## Errata to the Final Revised EIR

Since publication of the Final Revised Environmental Impact Report (EIR) for the Flood County Park Landscape Plan in October 2019, the San Mateo County Parks Department has undertaken the following actions that require text amendments to the Final Revised EIR:

Figure ERR-1 shows the revised layout of recreational elements at Flood County Park, as proposed in the January 2020 update to the Landscape Plan.

Figure 5 Proposed Parking Map

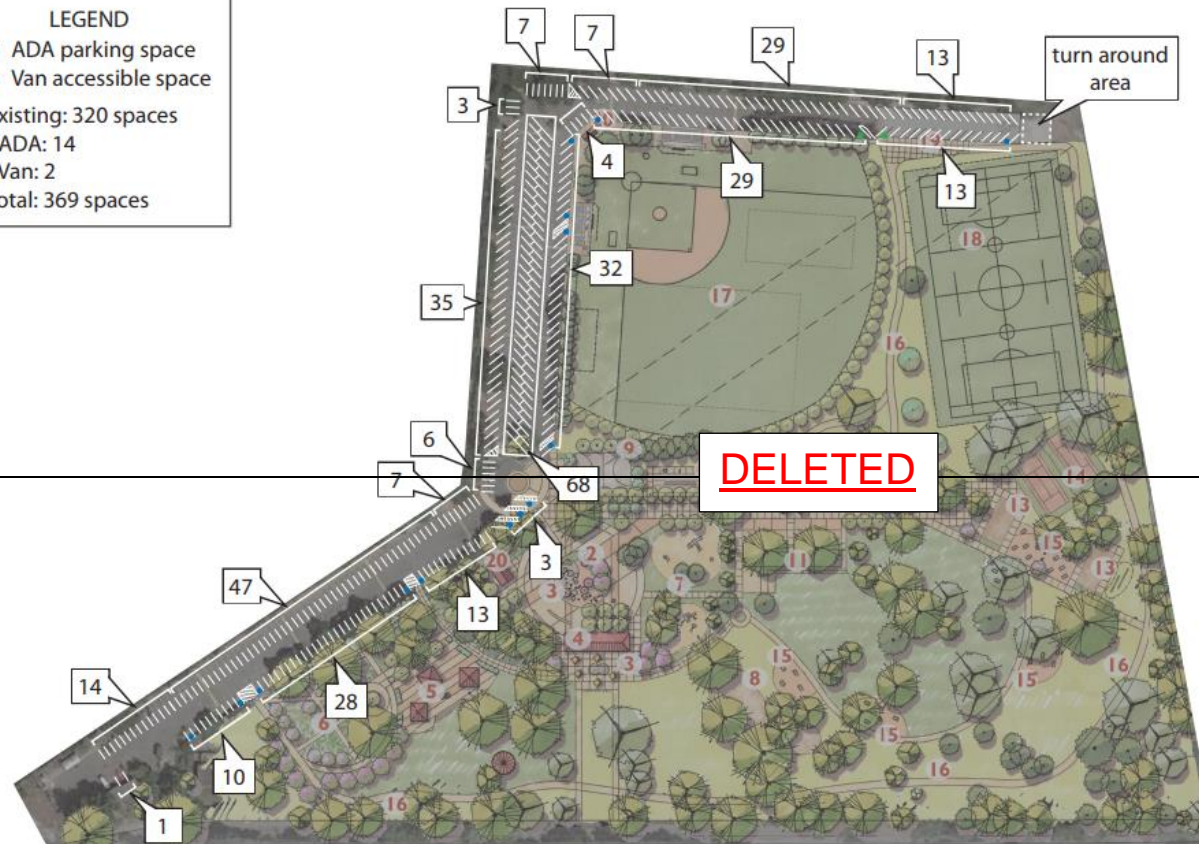
Pedestrians also would retain access to the park through entrances gaps along Bay Road and at the eastern gate from Iris Lane. An additional 26 parking spaces and a turnaround area would be added to the site of the existing pétanque court, as shown in Figure 4 and Figure 5, Proposed Parking Map. Twenty-three (23) new parking stall locations have been identified throughout the site in existing paved areas and include the following: one parking stall near the existing pay station; two

parking stalls in the island near the eastward turn near the ballfield; one stall in the island behind the ranger residence; one stall in the island on the south side of the eastward turn; seven stalls in the approximately 60 foot space and four stalls in the approximately 36 foot space before the pétanque court; and seven stalls by converting ADA van parking stalls to ADA car parking stalls. Therefore, an additional 23 stalls striped outside of the pétanque court and 26 stalls striped within the pétanque court would add a total of 49 new parking spaces at Flood Park. Please see Figure 5 for a layout of all 369 parking spaces. With the additional 49 parking spaces the Park would provide a total of 369 parking spaces.

LEGEND  
● ADA parking space  
● Van accessible space  
Existing: 320 spaces  
- ADA: 14  
- Van: 2  
Total: 369 spaces

**Figure 1 Proposed Landscape Plan**

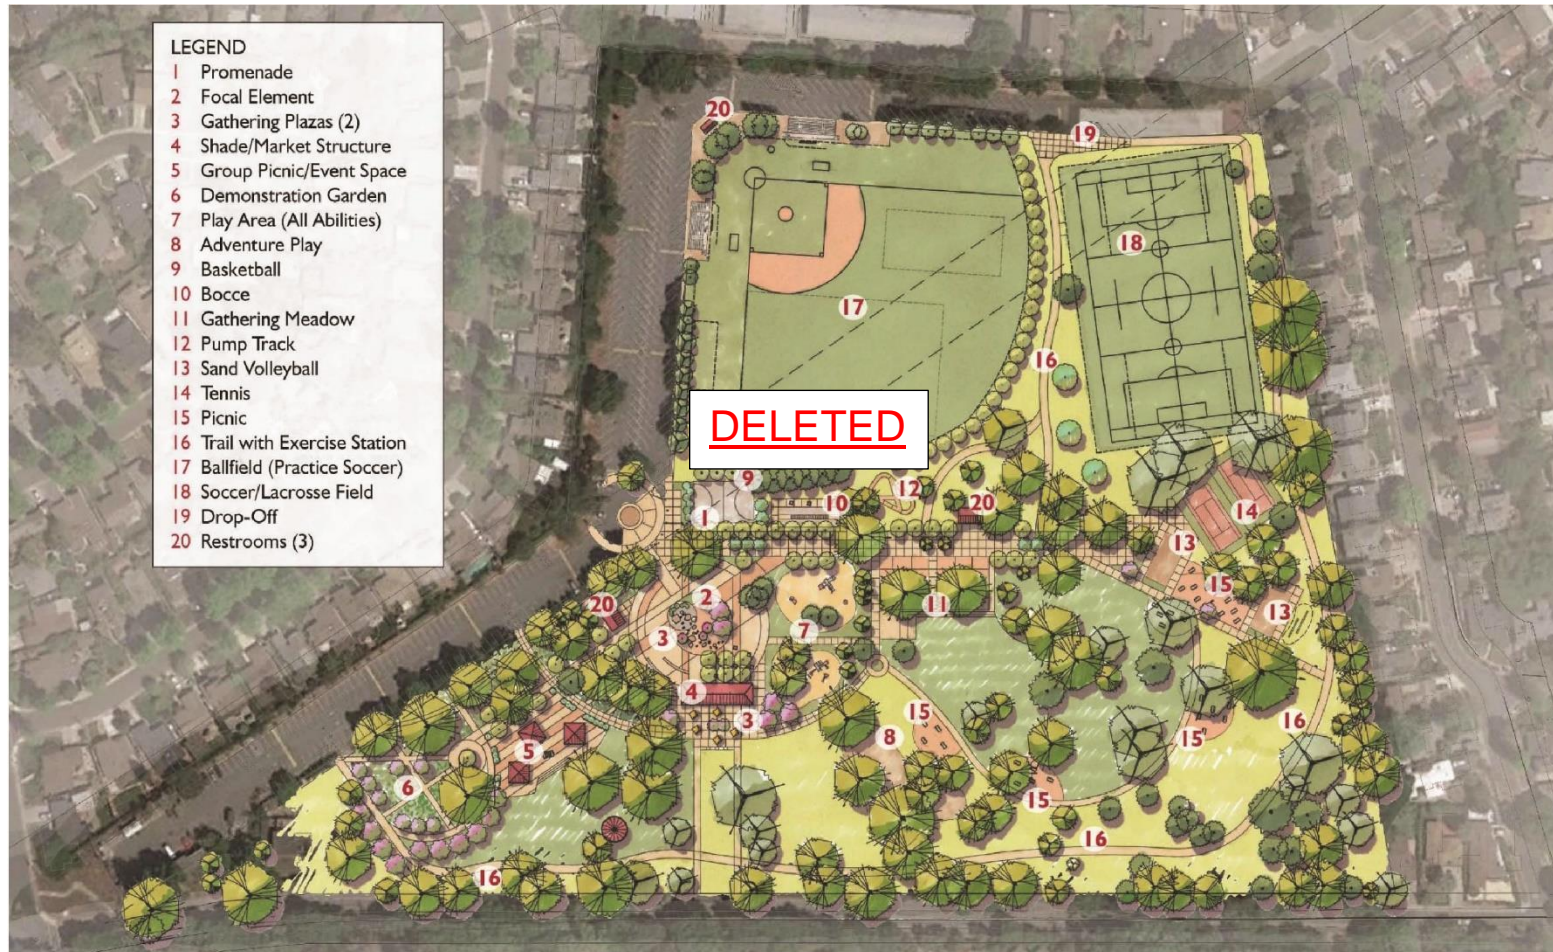
Figure 4 shows the layout of recreational facilities in the proposed Landscape Plan. As shown in this figure, the County has committed to siting all active recreational facilities including athletic fields and tennis courts at least 100 feet away from the property line adjacent to residences on Del Norte Avenue. Passive uses, like walking paths and group picnic areas, would be allowed in this setback. The following recreational facilities would be located within the SFPUC right-of-way: the multi-use ballfield/soccer/lacrosse field, basketball court, promenade, and a picnic area.

LANDSCAPE PLAN  
2020

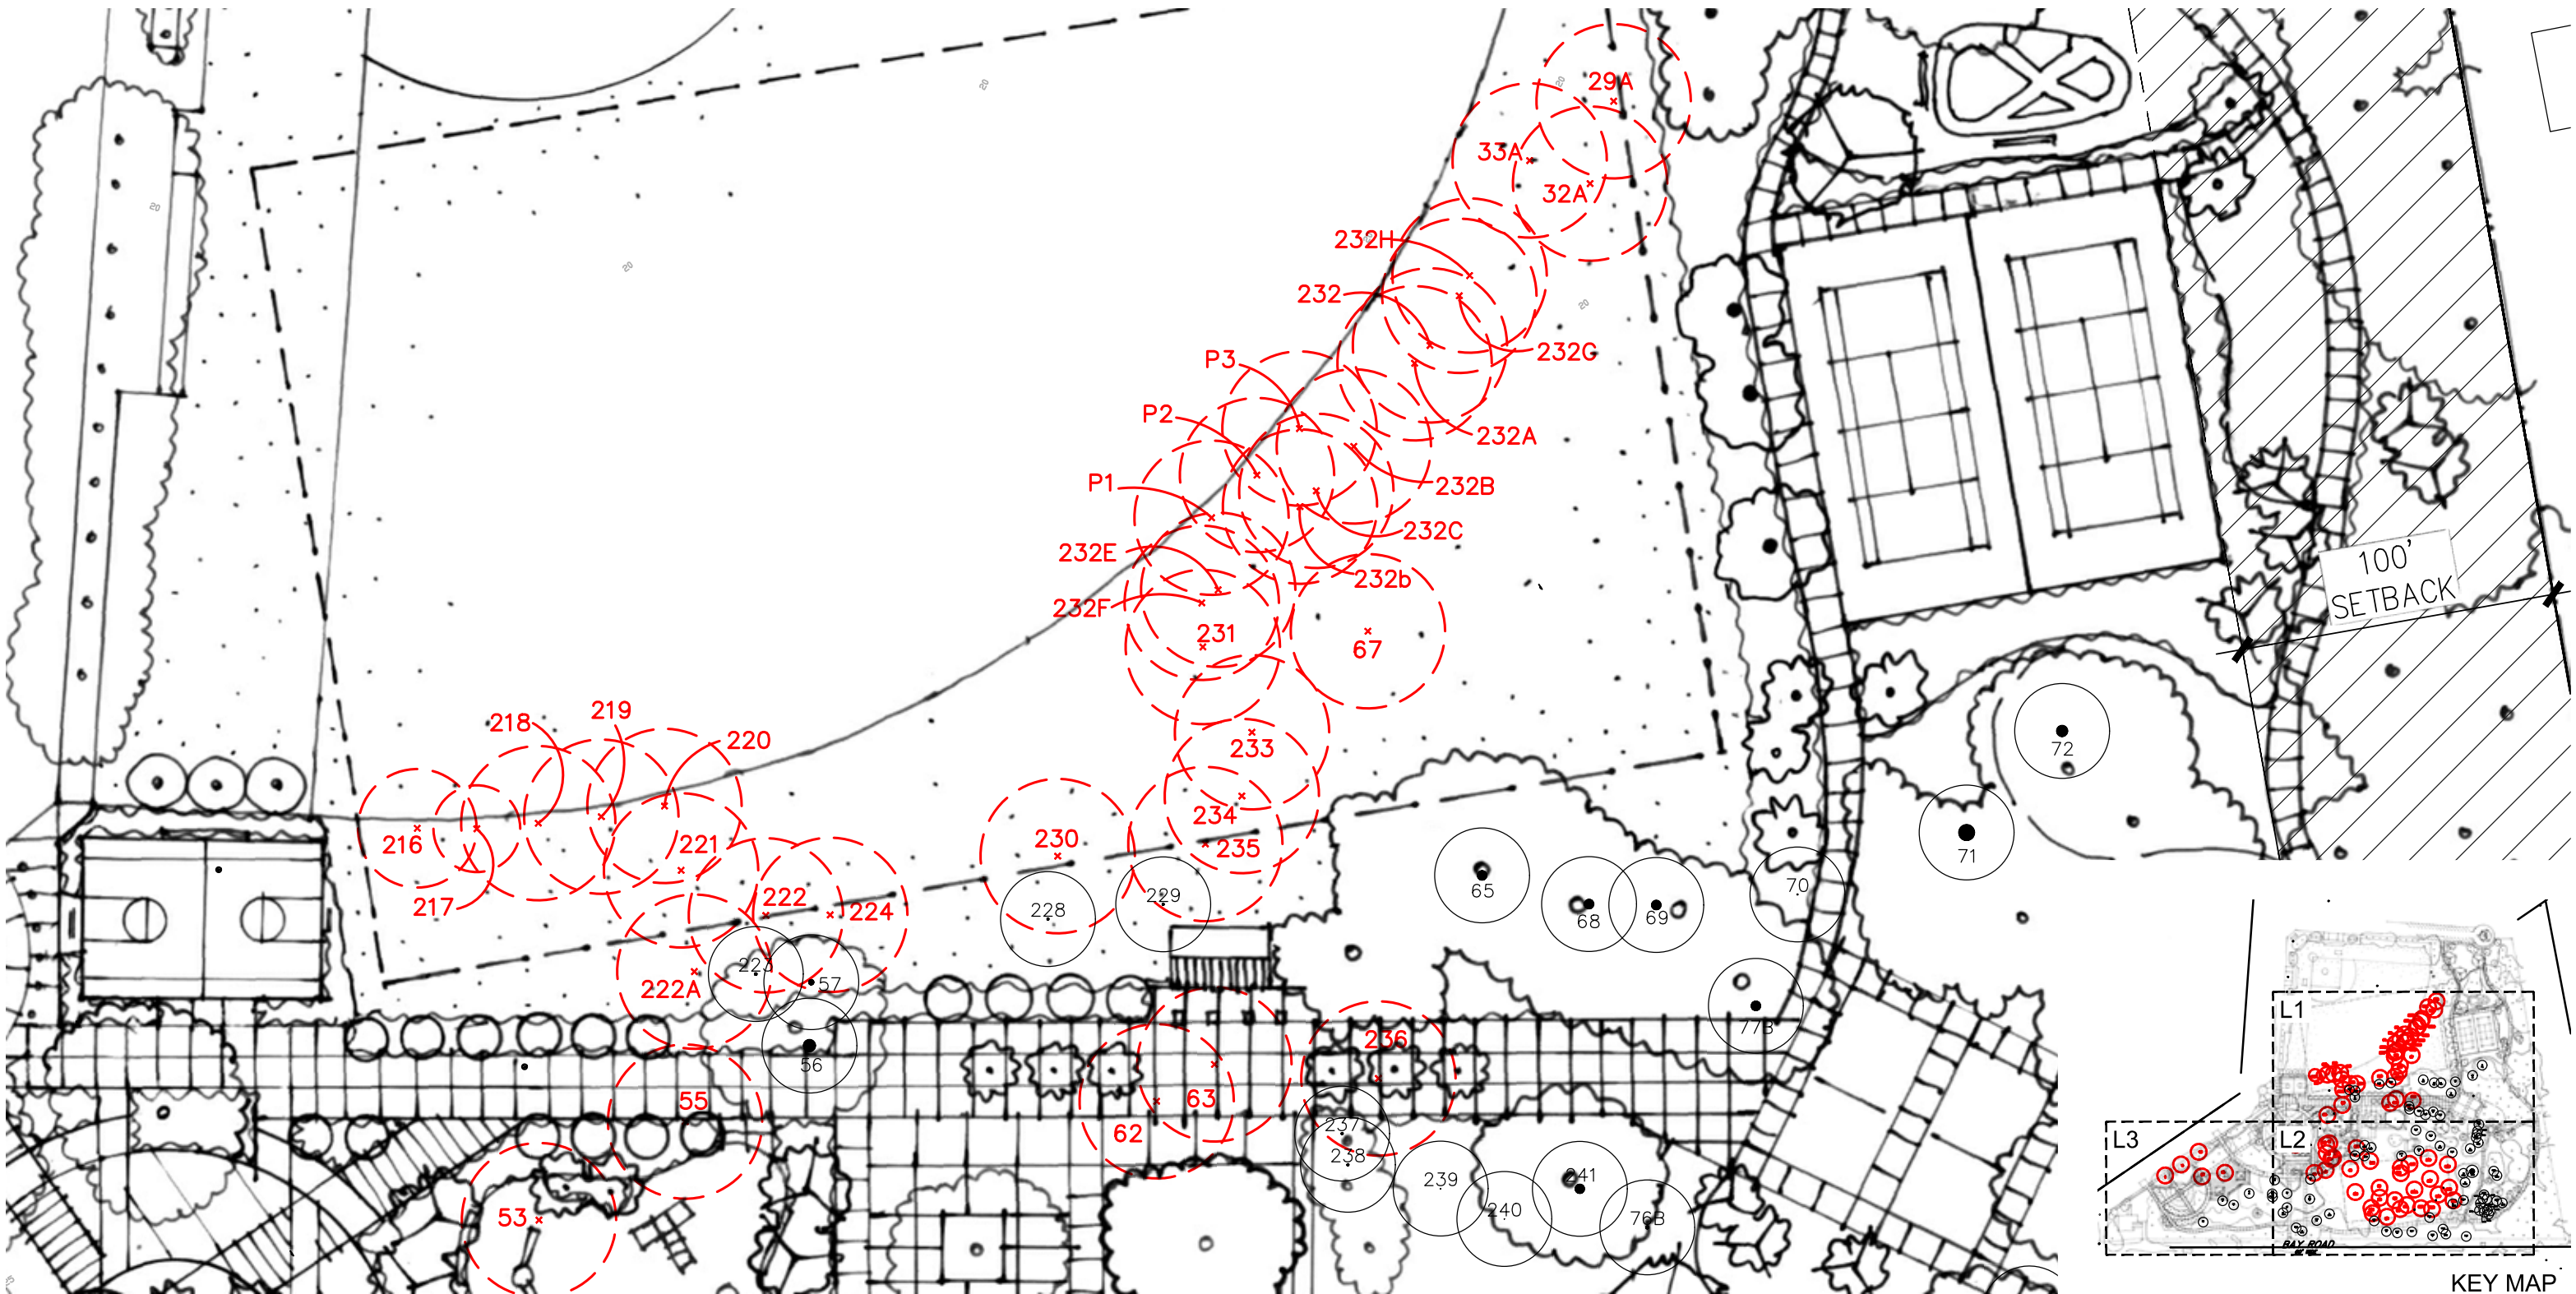
This report identifies trees that would be removed in the implementation of the 2020 Landscape Plan and compares the cumulative tree removal impact with the 2016 Landscape Plan. The Plan is at a "planning" level of detail and, as such, depending on the exact location, configuration and construction requirements of improvements, may undergo refinement as the project moves toward implementation. In subsequent phases, more detailed information will become available that allows adjustments to be made to address specific site conditions. As such, this report should be considered an approximation of tree removal given the current level of design detail.

The 2016 Landscape Plan had identified the cumulative removal of 80 trees. The 2020 Landscape Plan requires the cumulative removal of no more than 80 trees. None of the
